# Tooele Chemical Agent Disposal Facility (TOCDF)

**Request for a  
CLASS 2 MODIFICATION  
to the  
TOCDF RCRA Permit**

Request Number: TOCDF-DVS-02-1012  
Request Title: Area 10 Drum Ventilation System for  
Secondary Waste  
EPA ID Number: UT 5210090002

Figure 1 – Regulatory Status of DVS Components

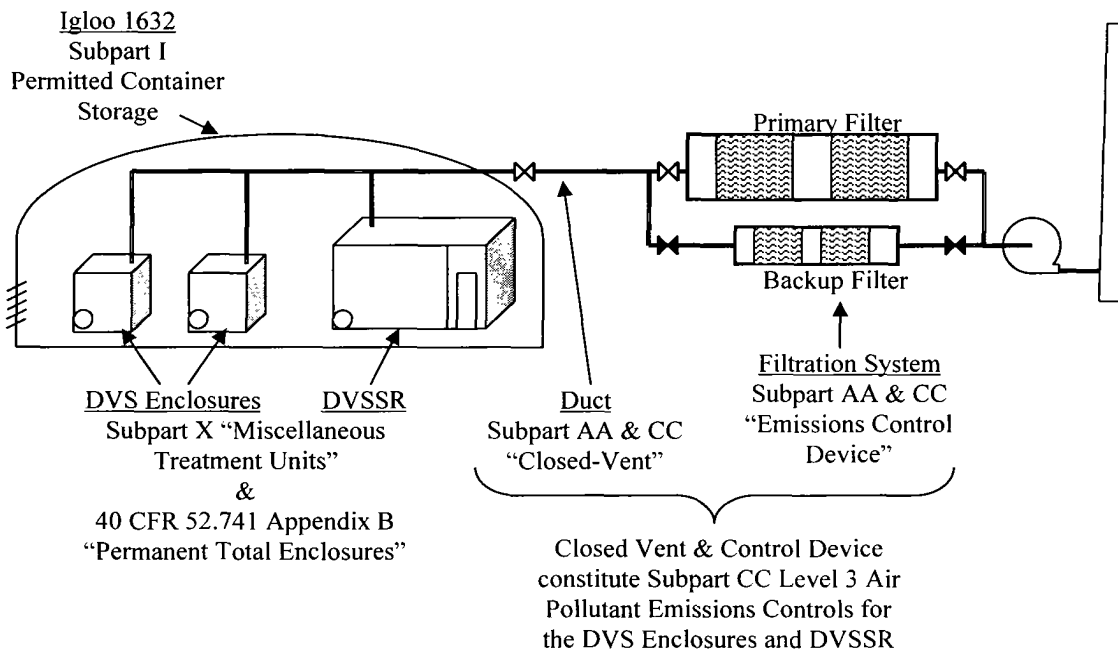
Refer to Enclosures 4.1, 4.2 and 4.3 of this request for drawings of the DVS Enclosures, the DVSSR, and their orientation within Igloo 1632. Figure 1 provides a schematic of the system, including the filtration system.

The Mustard TC Sampling gloveboxes have been completely removed from Igloo 1632 in order to make room for the two DVS Enclosures and the DVSSR. The DVS Enclosures and DVSSR will be connected to the Igloo Carbon Adsorption Filtration system in the same manner as the gloveboxes were. Igloo Carbon Adsorption Filtration system procedures used during the operation of the Mustard TC Gloveboxes will continue throughout the secondary waste operations of the DVS Enclosures.

In order to provide sufficient air pollutant emissions control for the DVS Enclosures and DVSSR, a closed-vent system will be installed that joins the DVS Enclosures and DVSSR directly with an emission control device in accordance with *Level 3* controls (superior to Level 2 controls) per 40 CFR 264.1086(e)(1)(i) and (e)(2)(ii). The closed vent system as well as the control device will be designed and operated in accordance with 40 CFR 264.1087.
